Product Change Notification / RMES-23FLBS013

CCB 3296.002 Final Notice: Qualification of MTAI as a new assembly site for selected ATMEGA1284x, ATMEGA16xxx, ATMEGA32xxx, ATMEGA644xx and ATMEGA85x5x device families available in 44L TQFP (10x10x1mm) package.

CCB 3296.002
Pre and Post Change Summary
PCN#: RMES-23FLBS013

Tray comparison

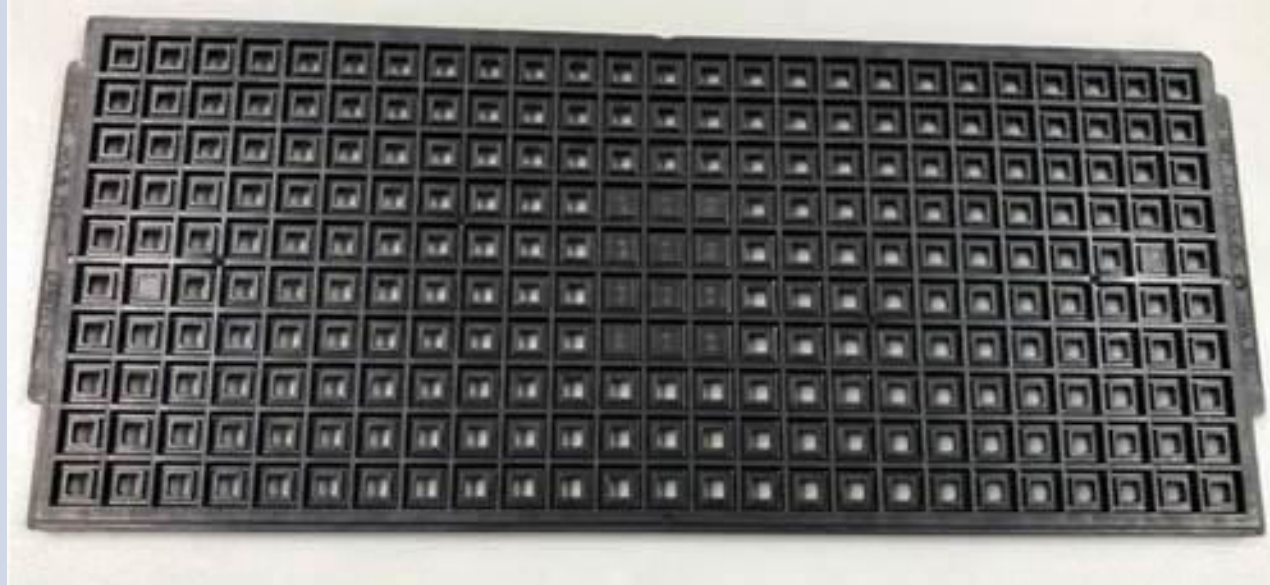
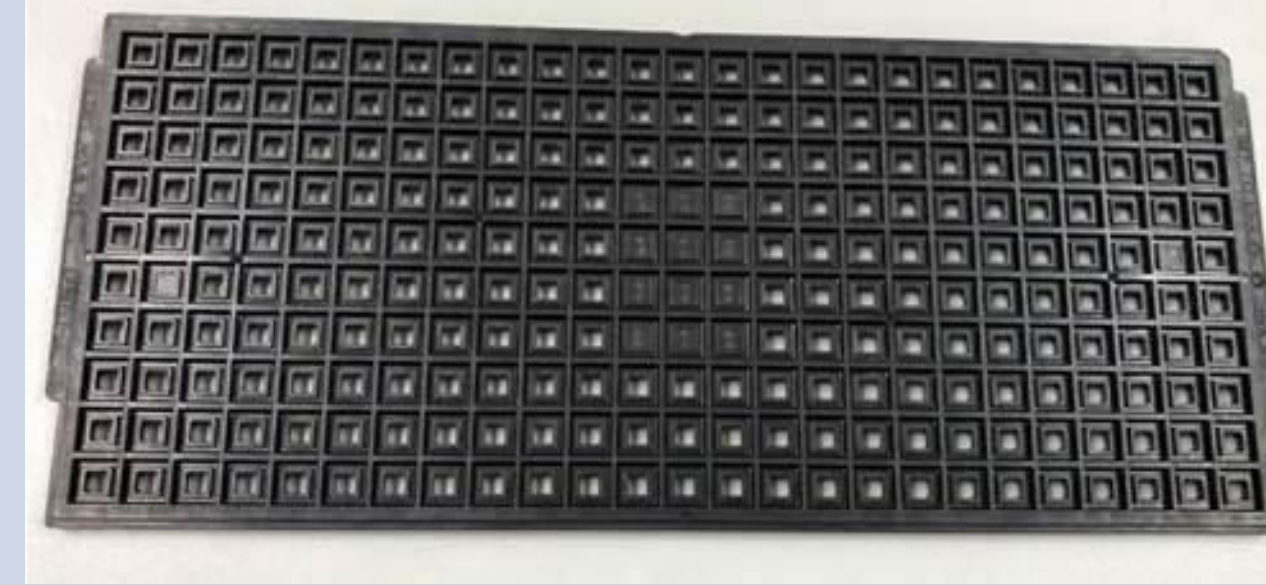
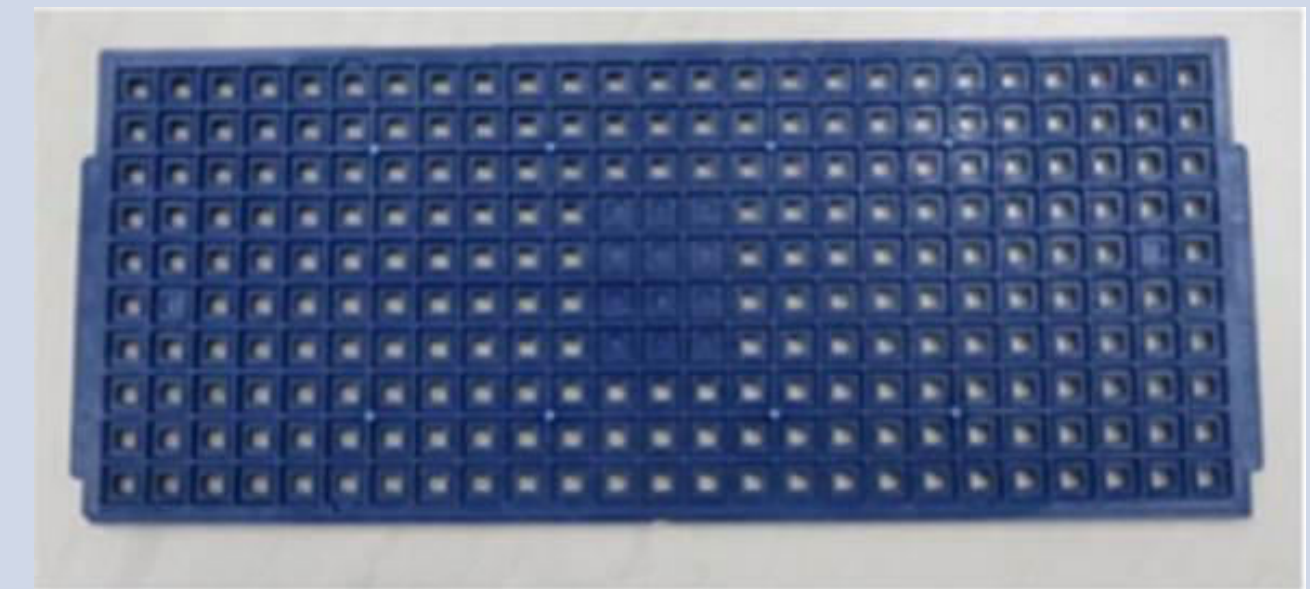
Pre change (LPI)	Post Change (MTAI)

Black Tray – Bakeable **or** Blue Tray - Non-bakeable
MSL Classification Level = 3	MSL Classification Level = 1
